A PEER REVIEW OF THE JANUARY 2013 STANTEC REPORT “WASTE RESOURCE STRATEGY UPDATE”

Halifax Regional Municipality - Solid Waste Resources

Rev. C04 > Internal ref. 511766-0001-T-EN-REP-0002

**RE: Peer Review of January 2013 Stantec Report for HRM titled
"Waste Resource Strategy Update"**

Figure 1 – Sample Locations

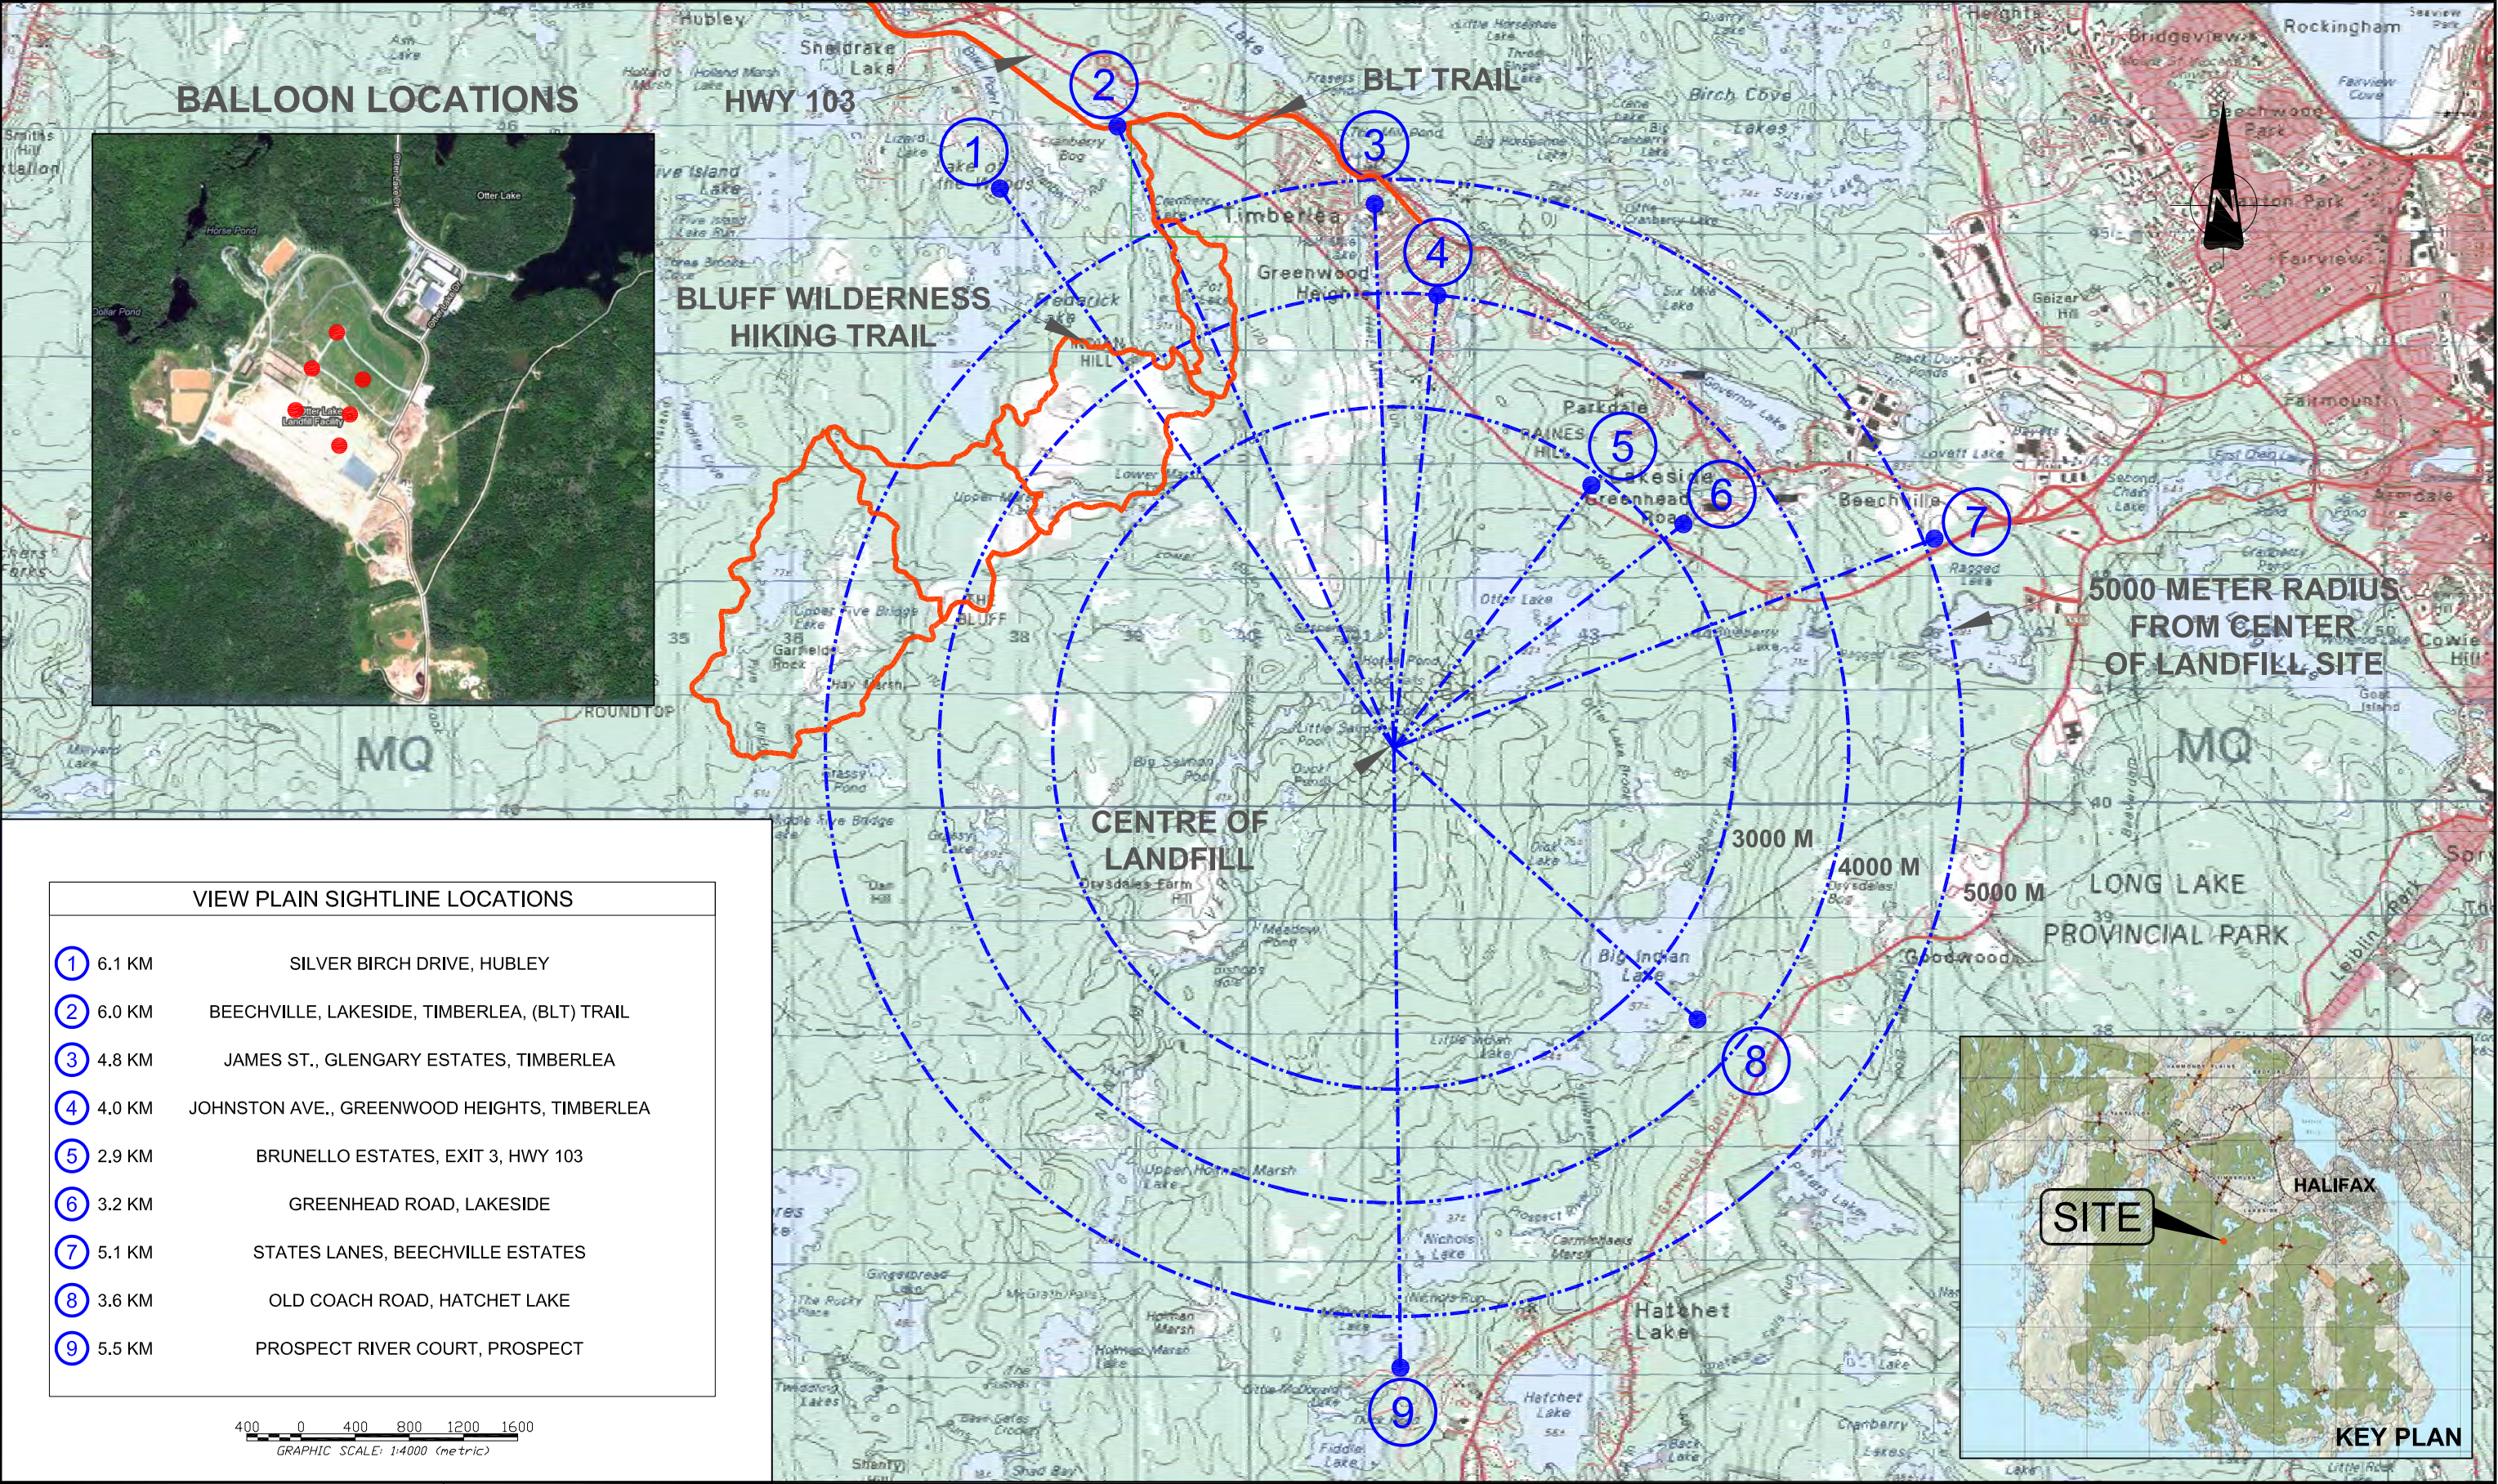
Figure 1 attached to this letter, indicates the relative location of our four samples:

The sample program in this investigation is not sufficient in size to claim the results as being representative of the conditions of these inherently heterogeneous waste streams, as a whole. However we find that the results provide an interesting relative measure of volatilization and leachate potential for the waste streams as represented by:

In our opinion, when considering the short term volatilization and leachate potential of the waste stream materials – with or without shredding; with or without stabilization - the difference in this potential for the full mix of materials, does not significantly change enough to compromise or overwhelm the capacity of the current gas management and leachate collection, transportation and treatment systems, to achieve the desired groundwater and air quality performance goals.
